Document last modified: 3/31/15

**CORRECTIONS FOR EROSION AND SEDIMENT POLLUTION CONTROL PROGRAM MANUAL
TGN 363-2134-008 March 2012**

**STANDARD CONSTRUCTION DETAIL # 7-12
Sediment Basin Emergency Spillway with Riprap Lining**

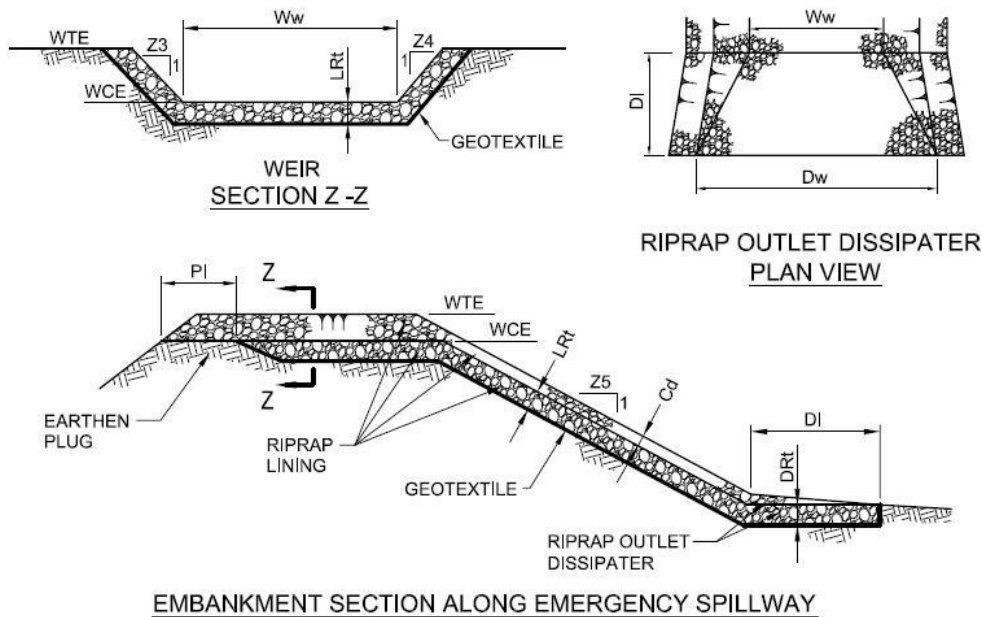
193

STANDARD CONSTRUCTION DETAIL # 13-4
Typical Trench Plug Installation

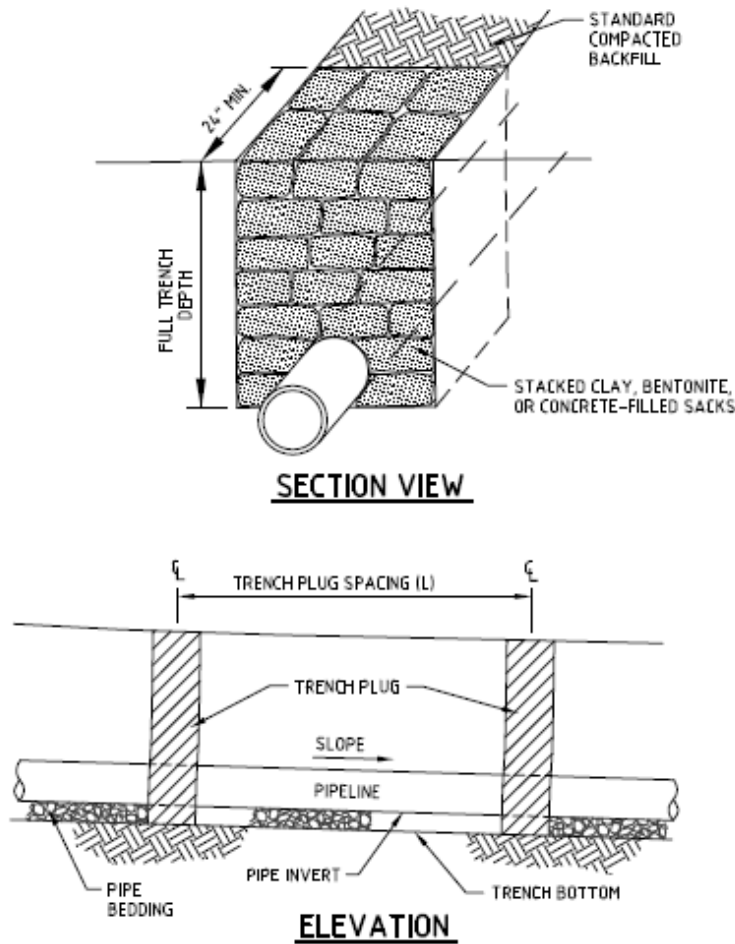
291
